## 6.0 ADMINISTRATIVE CONTROLS

FIGURE 6-2-1  
 SOUTH CAROLINA ELECTRIC & GAS COMPANY  
 VIRGIL C. SUMMER NUCLEAR STATION  
 FUNCTIONAL ORGANIZATION

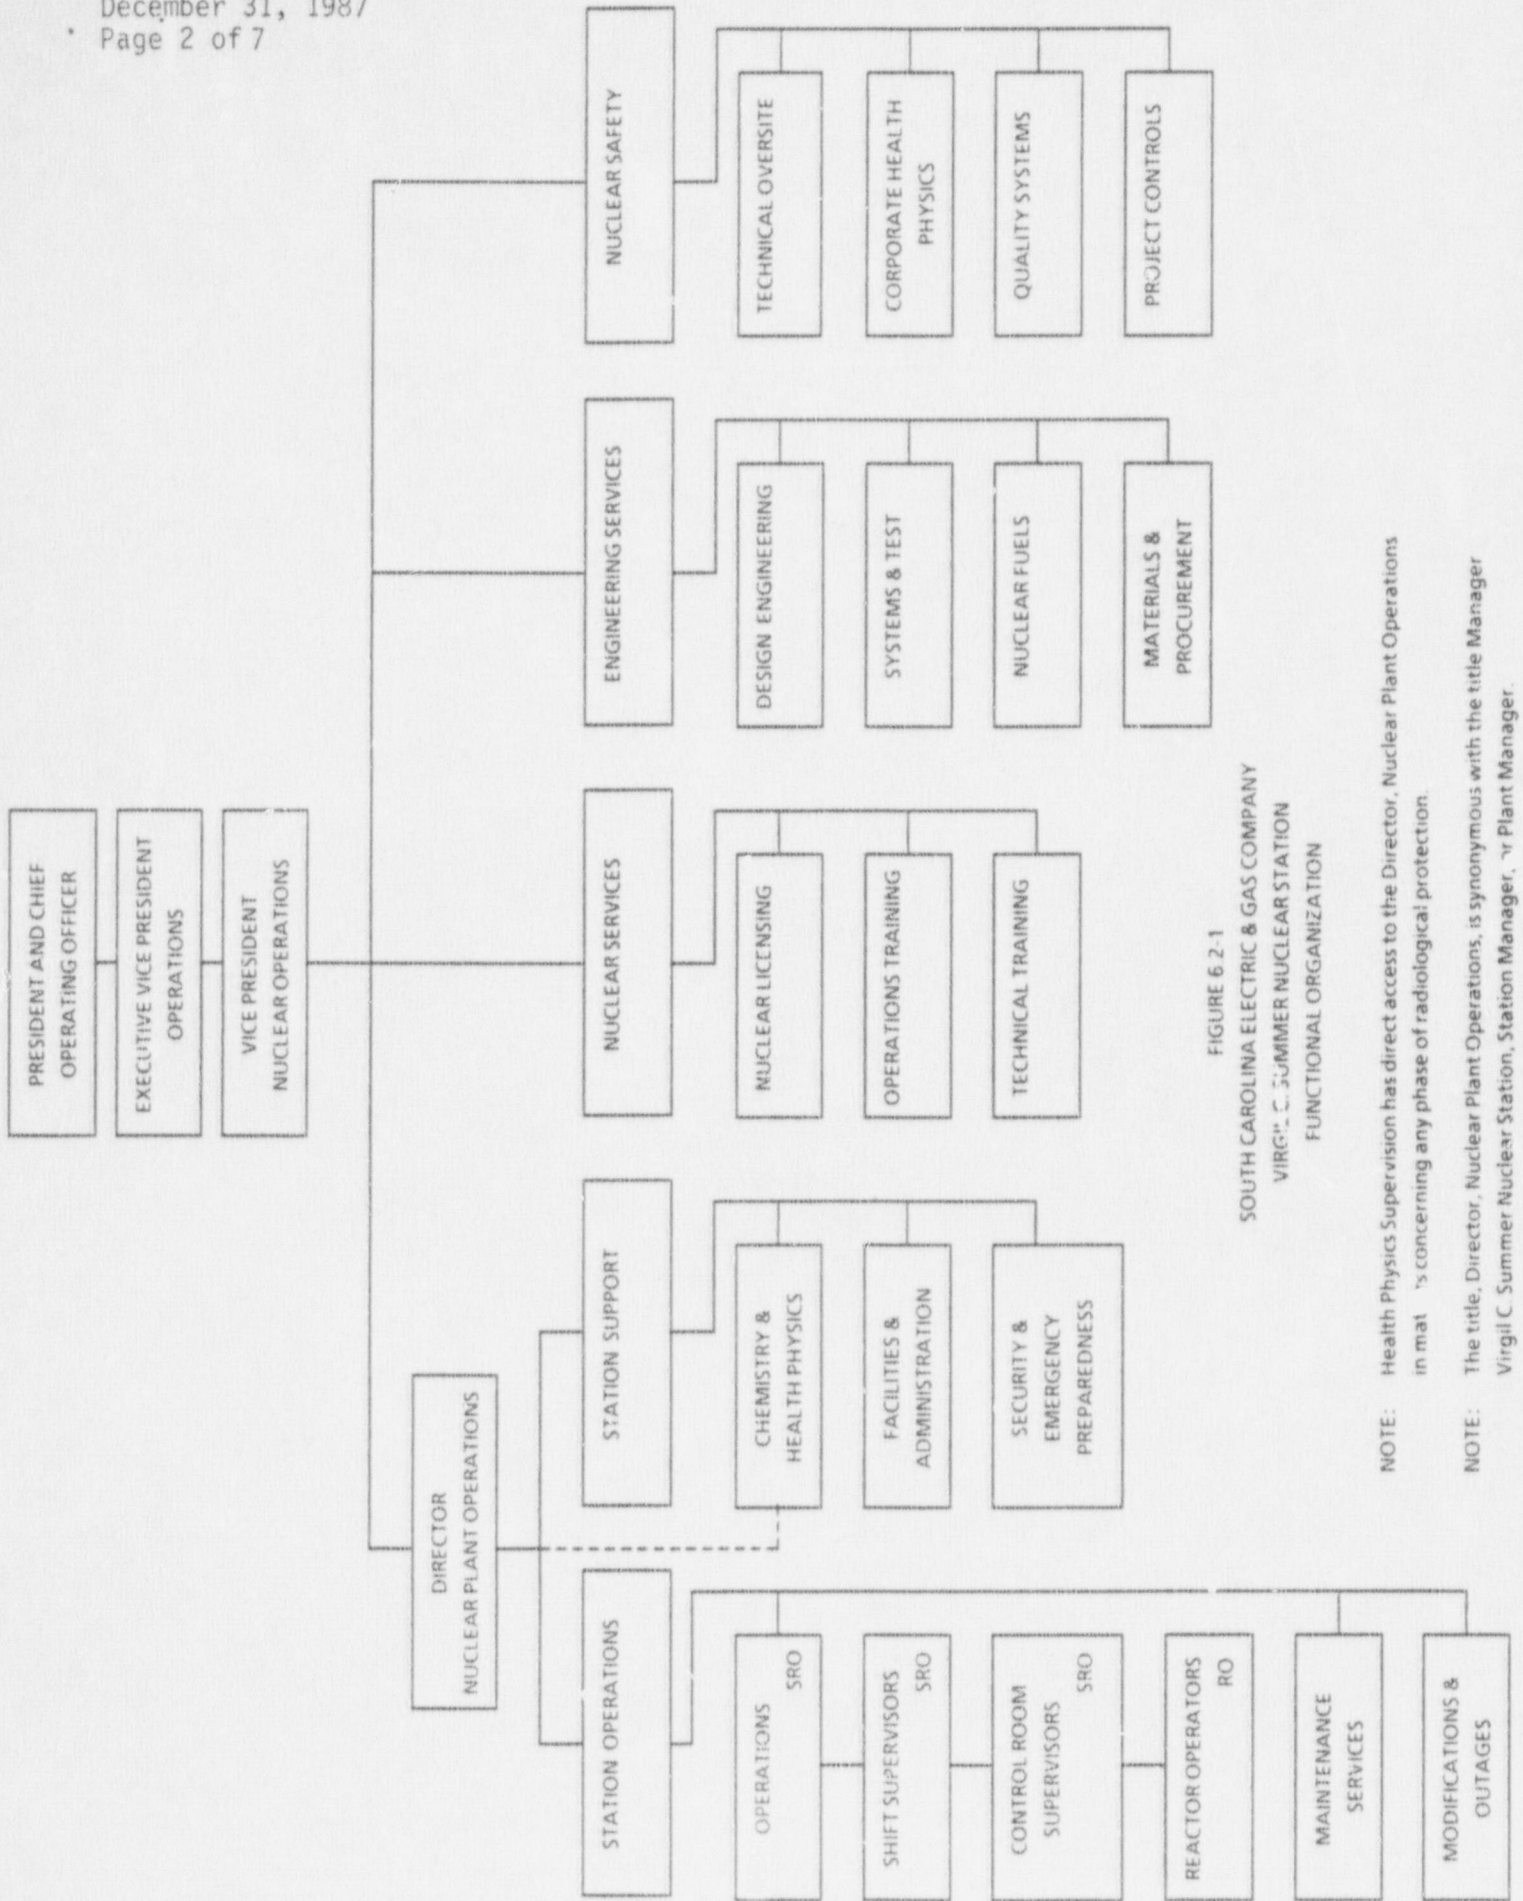
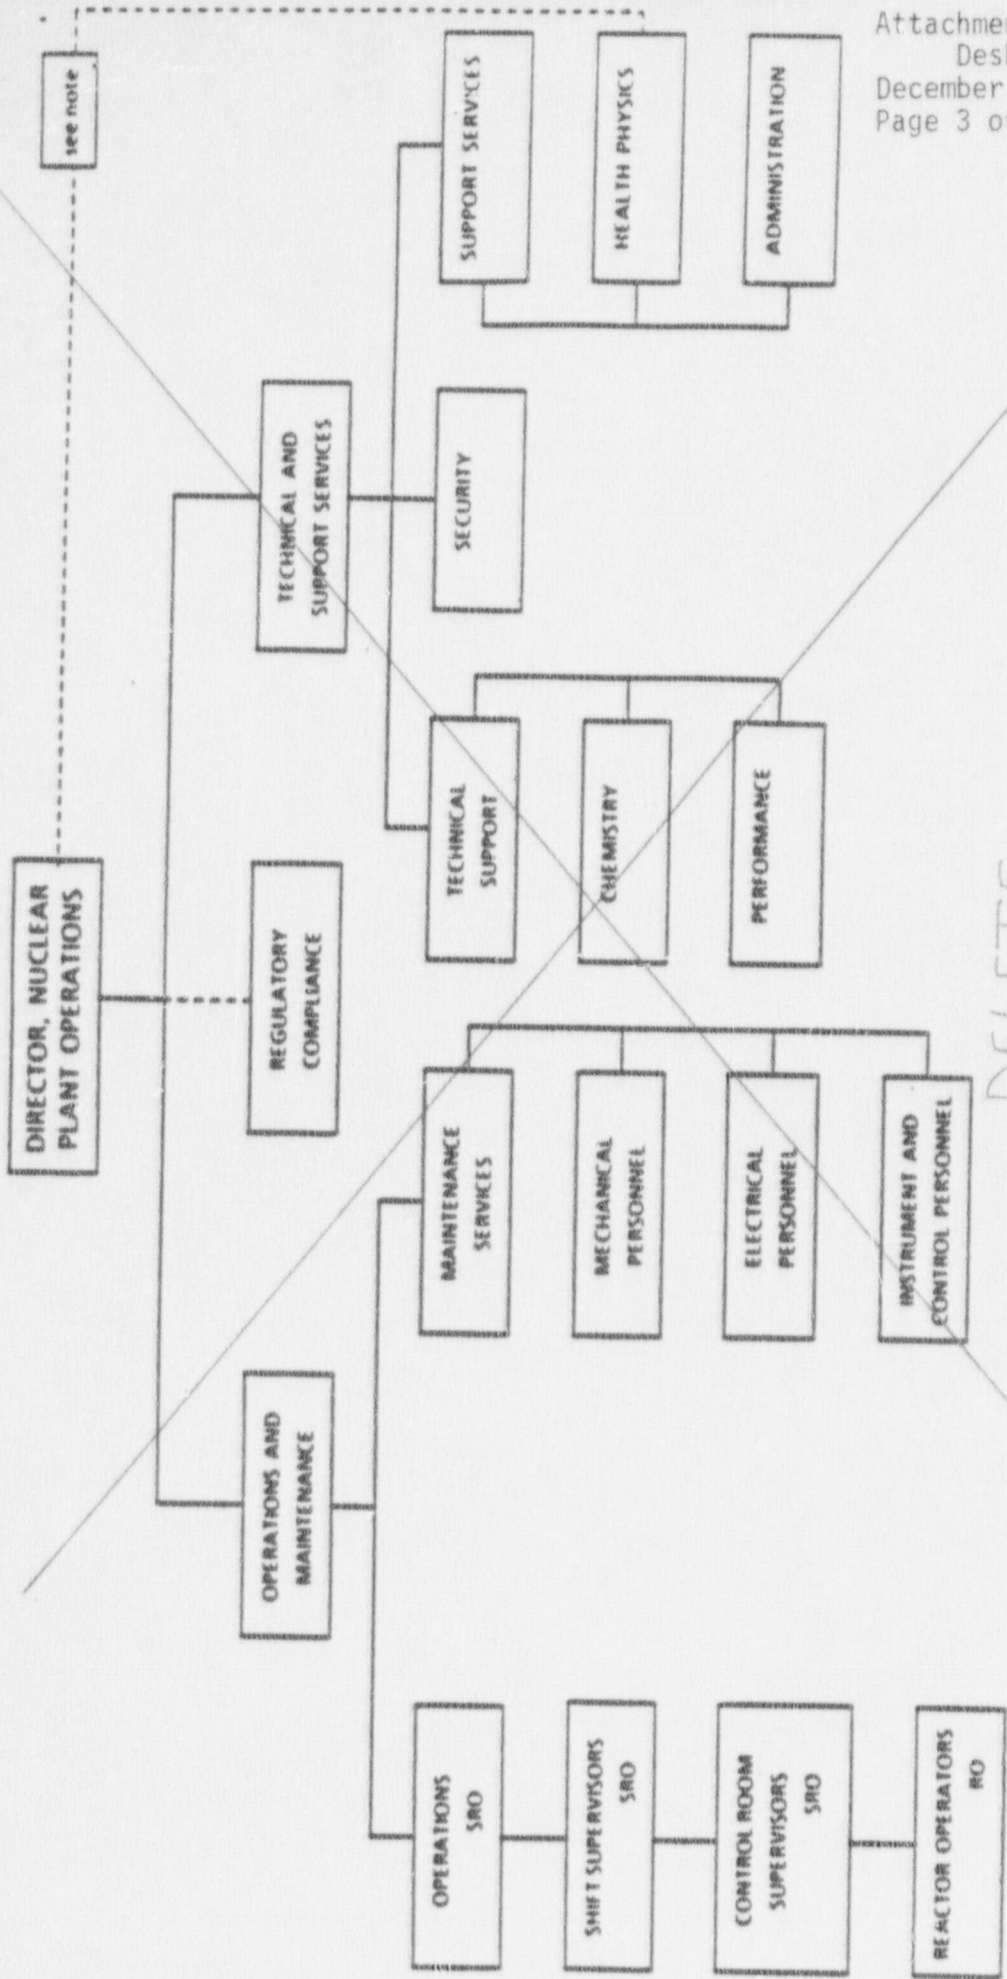
6.2.1 The <sup>FUNCTIONAL</sup> ~~offsite~~ organization for unit management and technical support shall be as shown on Figure 6.2-1. AND:

~~6.2.2 The unit organization shall be as shown on Figure 6.2-2 and:~~

DELETE

DELETE
